### CLARK COUNTY, NEVADA BID NO. 603283-14 THOMAS EDISON DRIVE, BRUCE WOODBURY DRIVE TO LAUGHLIN CIVIC DRIVE PULVERIZE AND PAVE

#### ADDENDUM NO. 1

THOMAS EDISON DRIVE, BRUCE WOODBURY DRIVE TO LAUGHLIN CIVIC DRIVE PULVERIZE AND PAVE  
PWP NUMBER: CL-2014-205  
Revised Per Addendum No. 1

**PAVEMENT REPLACEMENT PLAN**

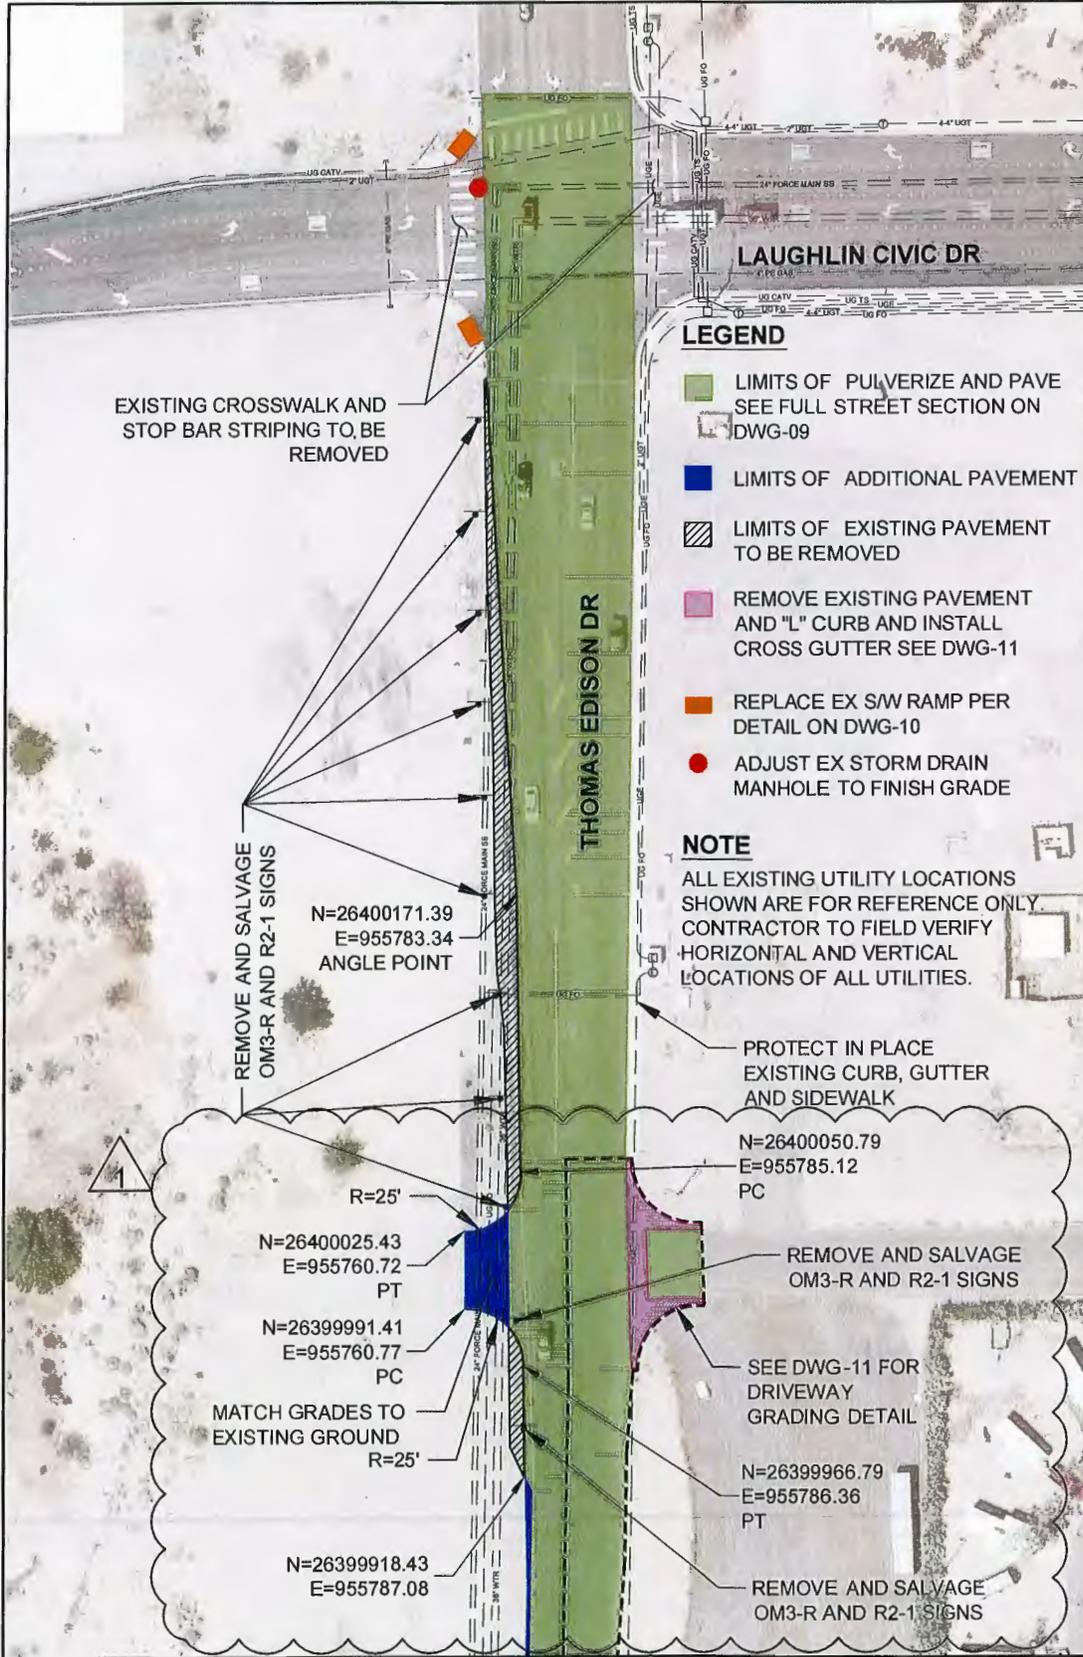
4. **Drawing No. 04**, Added driveway on west side of Thomas Edison Dr.
5. **Drawing No. 14**, Added Sheet
6. **Drawing No. 14.1**, Added driveway, updated striping, signage, legend and drawing number
7. **Drawing No. 15**, Updated dimension and drawing reference
8. **Drawing No. 38**, Updated striping, legend and add signage
9. **Drawing No. 39**, Show existing sign

04/23/2014 - PER ADDENDUM #1  
ADDED DRIVEWAY ON WEST SIDE OF THOMAS EDISON DR

**SIGNING AND STRIPING PLAN**

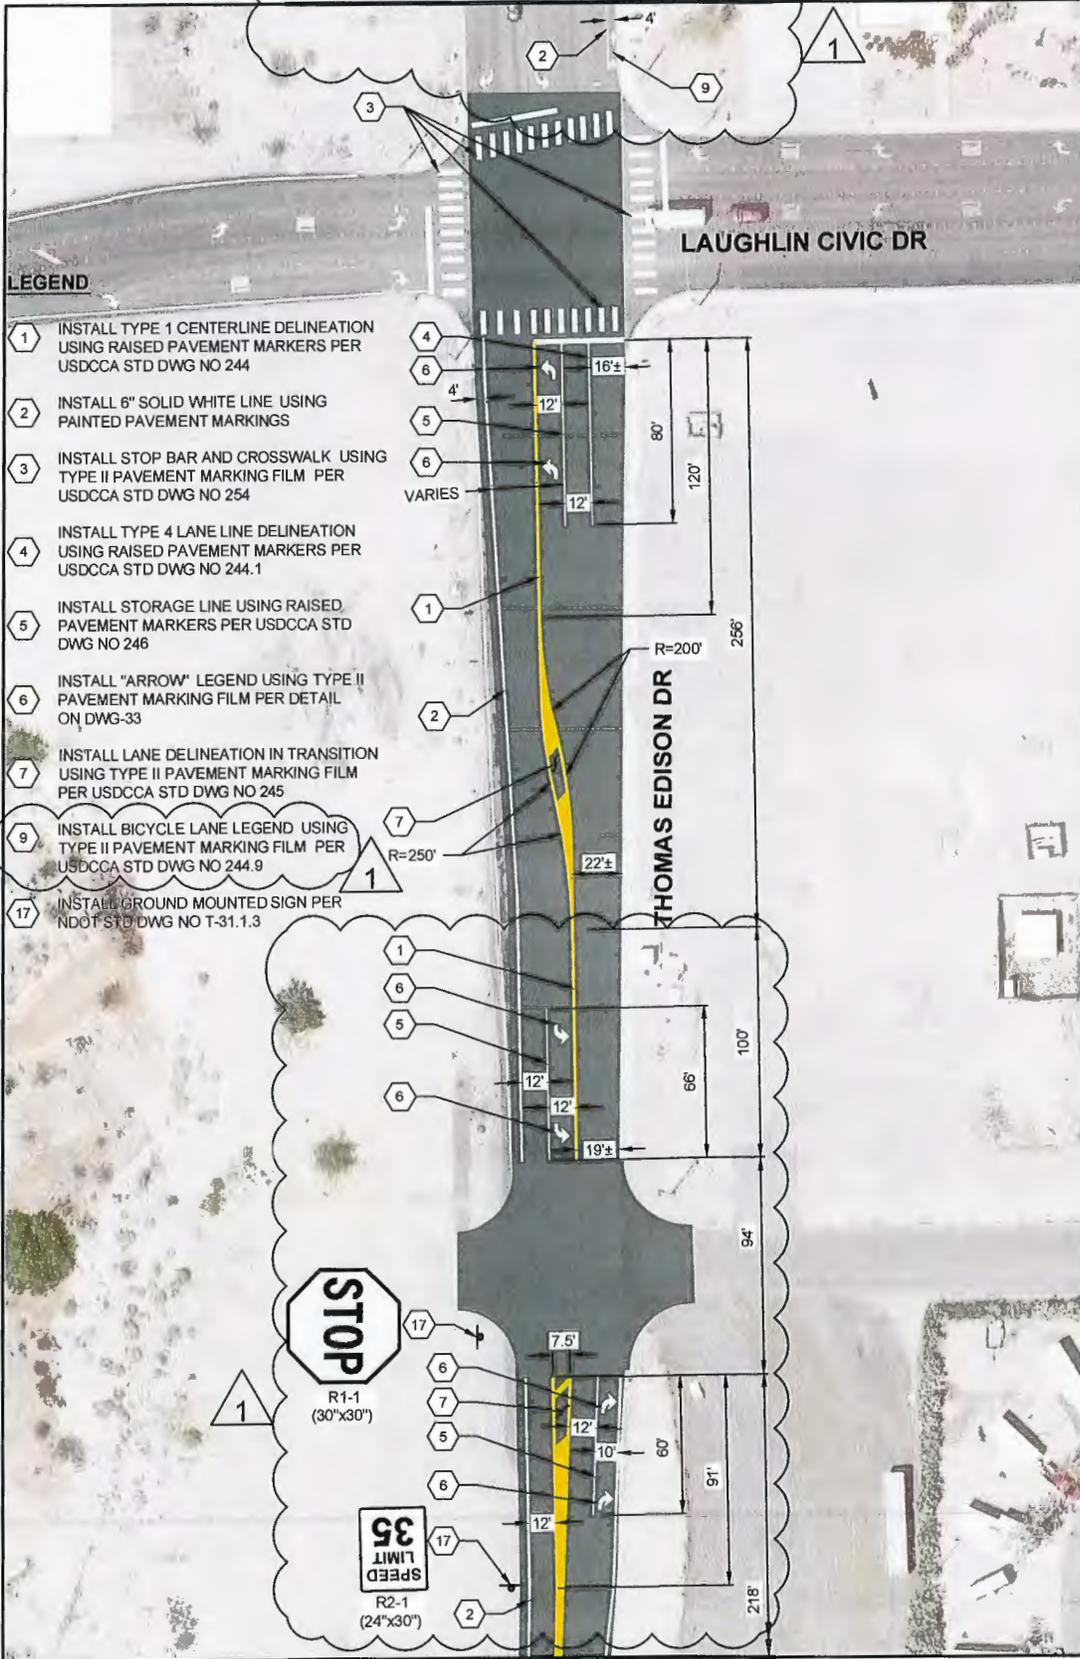
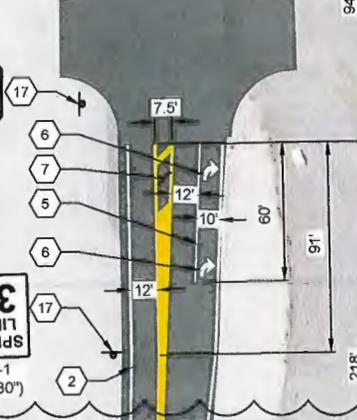
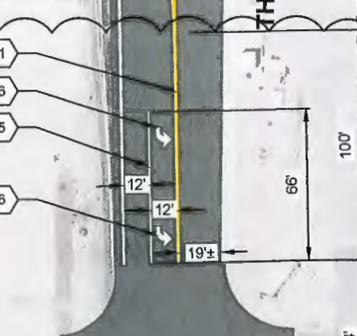
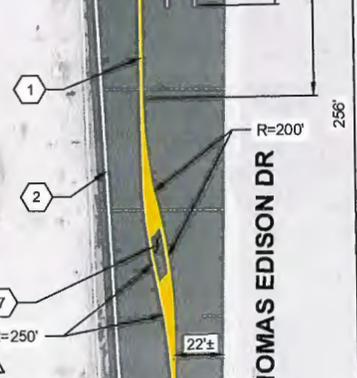
REVISION  
 04/23/2014 - PER ADDENDUM #1  
 ADDED DRIVEWAY, UPDATED STRIPING,  
 SIGNAGE, LEGEND AND DRAWING NUMBER

DWG - 15

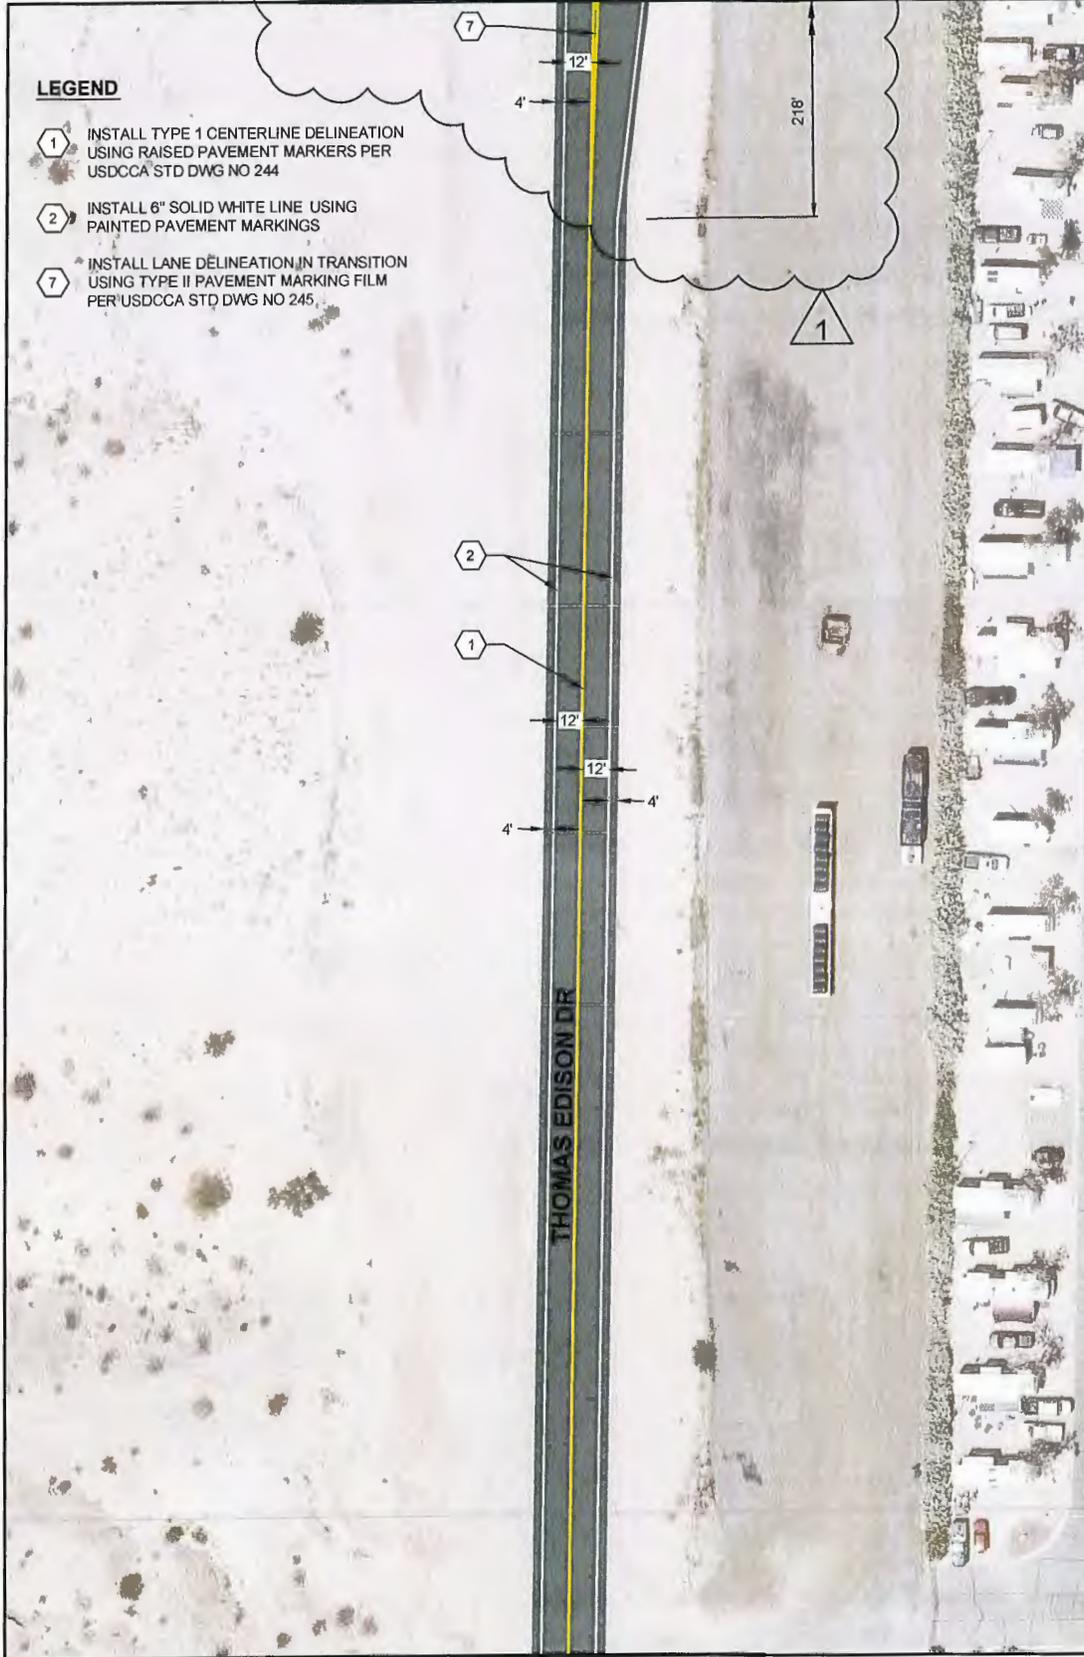
- 04/23/2014 - PER ADDENDUM #1  
UPDATED DIMENSION AND DRAWING  
REFERENCE
- 1

**STRIPING PLAN**

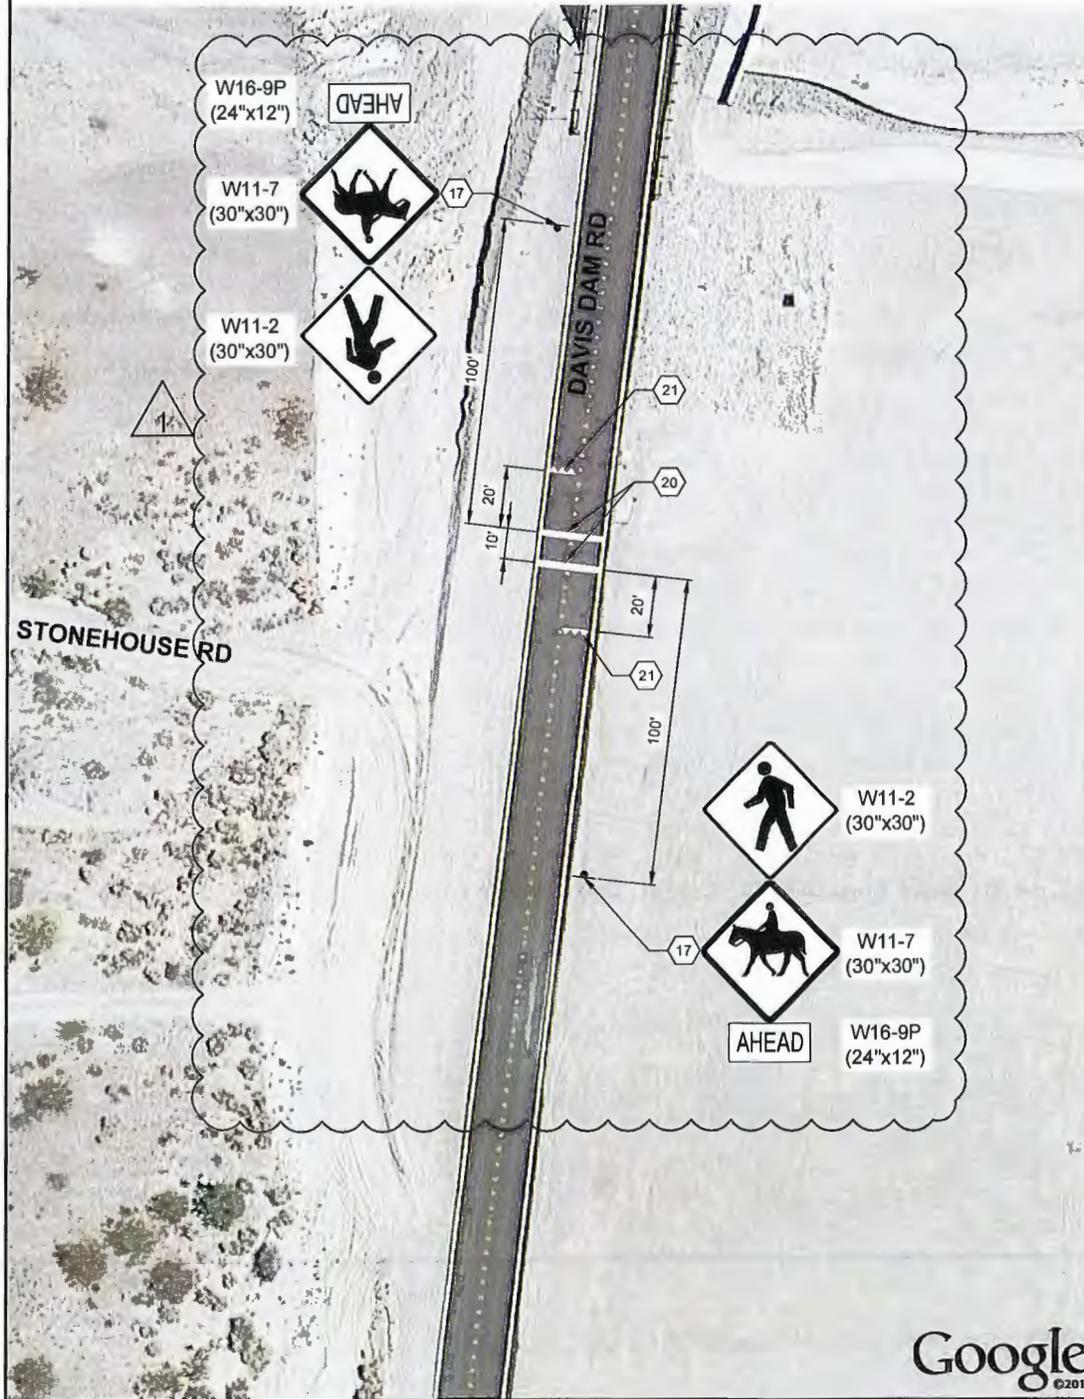
- 04/23/2014 - PER ADDENDUM #1
-  UPDATED STRIPING, LEGEND AND ADD SIGNAGE
